Arlington Conservation Commission

Date: Thursday, May 2, 2024

DEP #091-0356: Notice of Intent: Thorndike Place (Continued from 4/18/2024).

The Conservation Commission will hold a public hearing under the Wetlands Protection Act to consider a Notice of Intent for the construction of Thorndike Place, a multifamily development on Dorothy Road in Arlington.

Groundwater Mounding Analysis Design

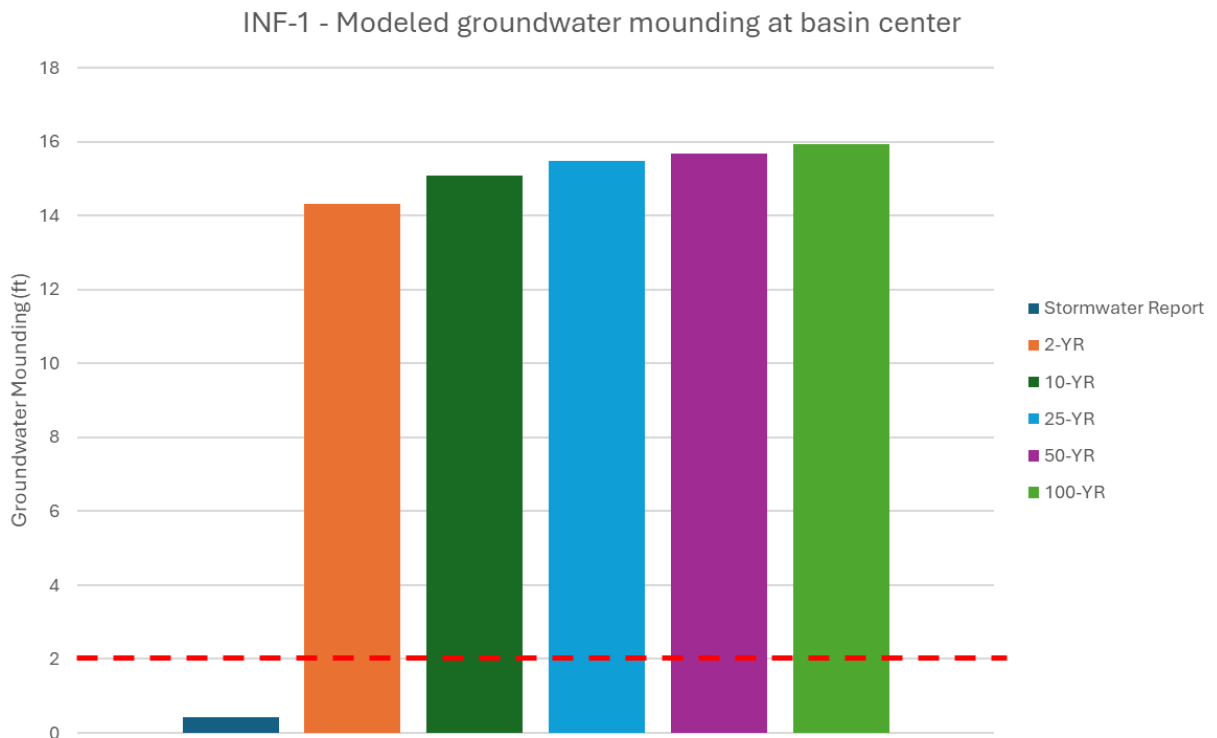
Based on MMA's review, the Applicant appears to misinterpret guidance provided by the Mass. SW Handbook relative to conducting (groundwater) mounding analyses. Specifically, the Applicant incorrectly views a reference to *Required Recharge Volume* (RRV) used in the Mass. SW Handbook as a direct instruction for designing a specific loading scenario under which to evaluate resultant groundwater mounding. In the Mass. SW Handbook's discussion of mounding analysis requirements, the RRV is not being singularly used to define a specific volume of infiltration produced by an individual, hypothetical storm event, as the Applicant represents in their mounding analysis. Instead, the RRV term is being used in the Mass. SW Handbook to more generally refer to the volume of internal storage provided by the proposed infiltration practice that would fill during a storm and slowly drain via exfiltration/infiltration.

In MMA's experience, the common accepted practice for conducting mounding analyses that meet Mass. SW Handbook requirements is to use infiltration rates ***and durations*** representative of the largest (i.e., lowest probability) design events for which rate control is being provided. This approach is logical because, as acknowledged in BSC's 2021 Report, severe groundwater mounding can result in adverse hydraulic impacts that may reduce exfiltration/infiltration rates. This effect may, in turn, compromise the ability of a system to provide the intended rate control function. Our position on this matter is supported by the Mass. SW Handbook excerpts provided below, which generally refer to the need to illustrate full drainage of system storage under contemplated storm events, not just drainage capability under an artificial case based on the specific volume definition of the RRV:

- *"Infiltration structures must be able to drain fully within 72 hours"* – Vol. 1, Ch. 1.
- *"Design the subsurface structure so that it drains within 72 hours after the storm event and completely dewater between storms"*. – Vol. 2, Ch. 2.
- *"Design the system to totally exfiltrate within 72 hours"*. – Vol. 2, Ch. 2.
- *"If the [mounding] analysis indicates the mound will prevent the infiltration BMP from fully draining within the 72-hour period, an iterative process must be employed to determine an alternative design that drains within the 72-hour period"*. – Vol. 3, Ch. 1.

Figure 9. FEMA FIRMette for Site

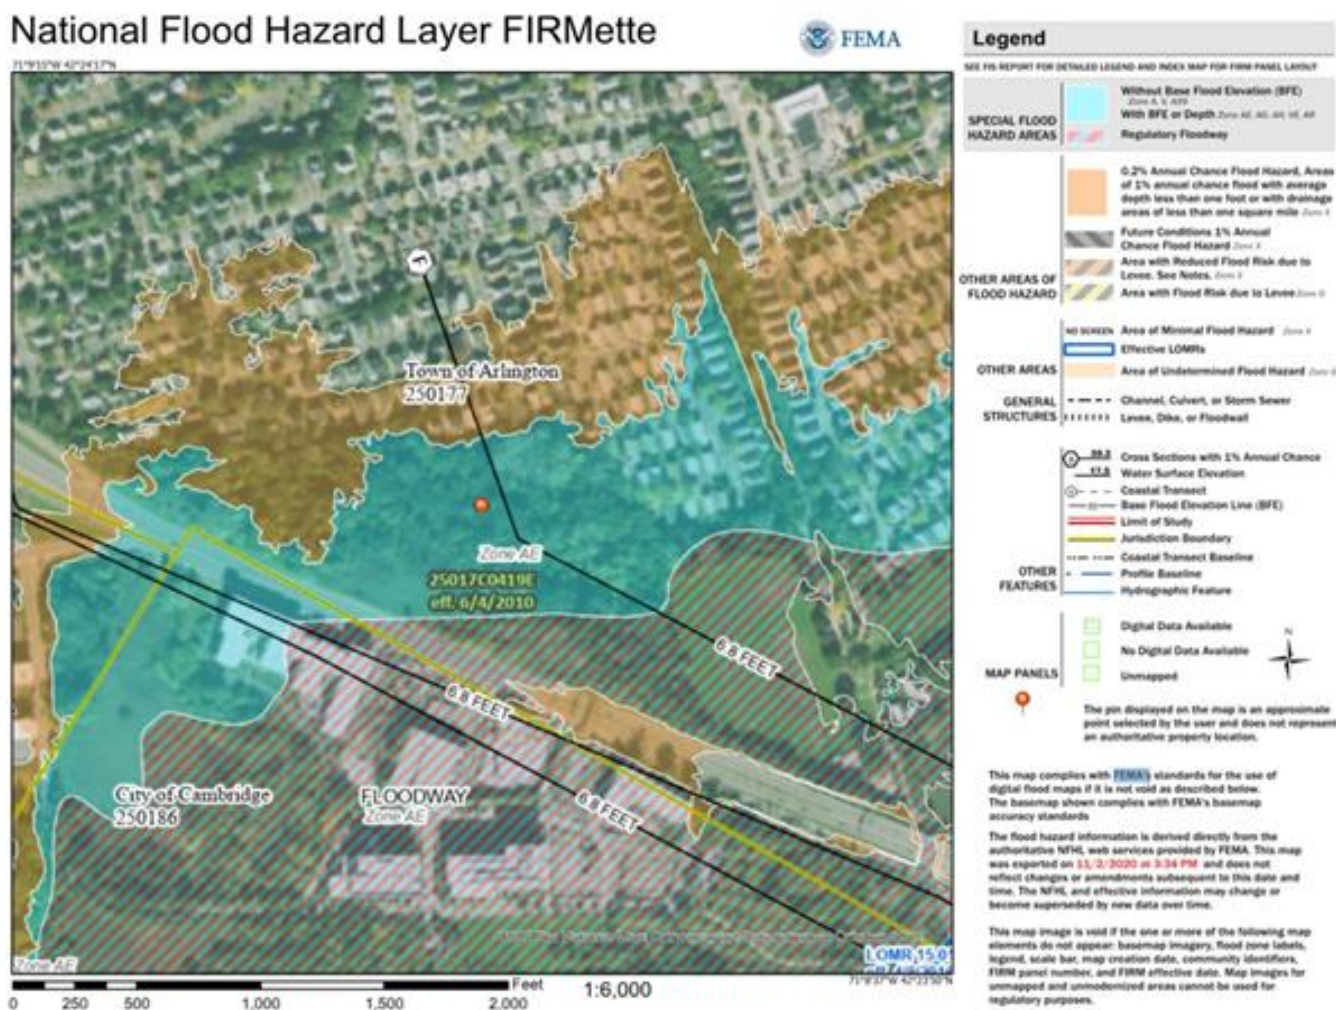
Alewife Brook (Little River)² created by FEMA, the 500-year elevation for the Site is 10.75 feet NAVD88. Furthermore, all of FEMA's elevations for the Site are based on data collected up to June 4, 2010, and do not consider SLR or SS effects due to climate change. The first floor living space for the Thorndike Place development is designed at an elevation of approximately 13 feet-NAVD88, making it suitable for projected SLR and SS effects, but the underground parking area is at a severe risk of flooding.

Figure 10. Map from the BH-FRM showing the 2070 1% Annual Chance Flood

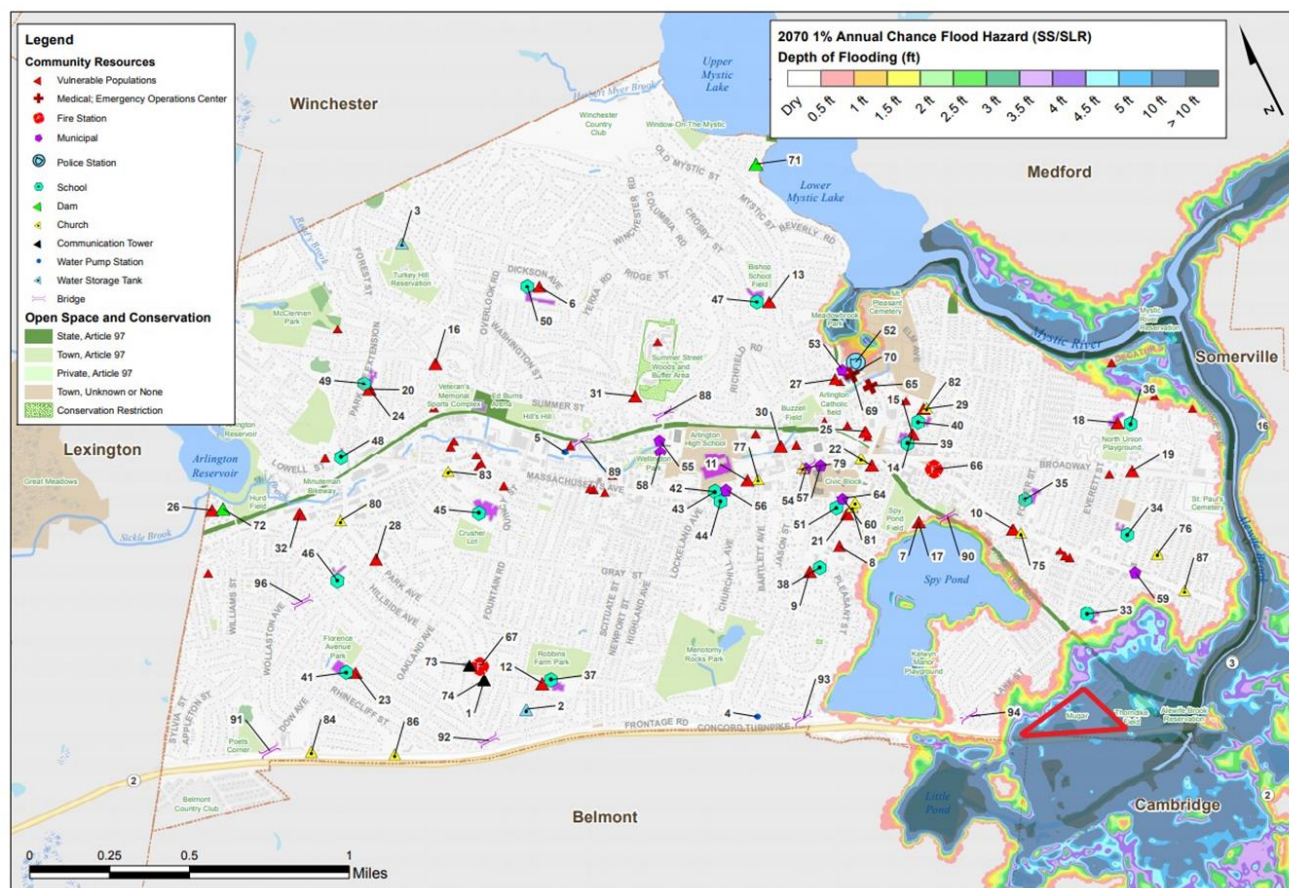
proposed development site, and the site is likely to experience a greater than 20% annual probability of flooding by 2070.³ The Department of Conservation and Recreation (DCR) is actively undertaking a Feasibility Analysis on raising and extending the AED and pursuing this effort in coordination with regional resiliency efforts. The timeline for these improvements is uncertain, which is why the Thorndike Place Development should consider these future flooding impacts. Figure 10 shows a map of the 1% annual chance flood depth projected throughout Arlington for 2070 by the BH-FRM, which was the model used in the Cambridge Climate Change Vulnerability Assessment. This map indicates a projected flood depth of at least 10 feet throughout the Mugar site.
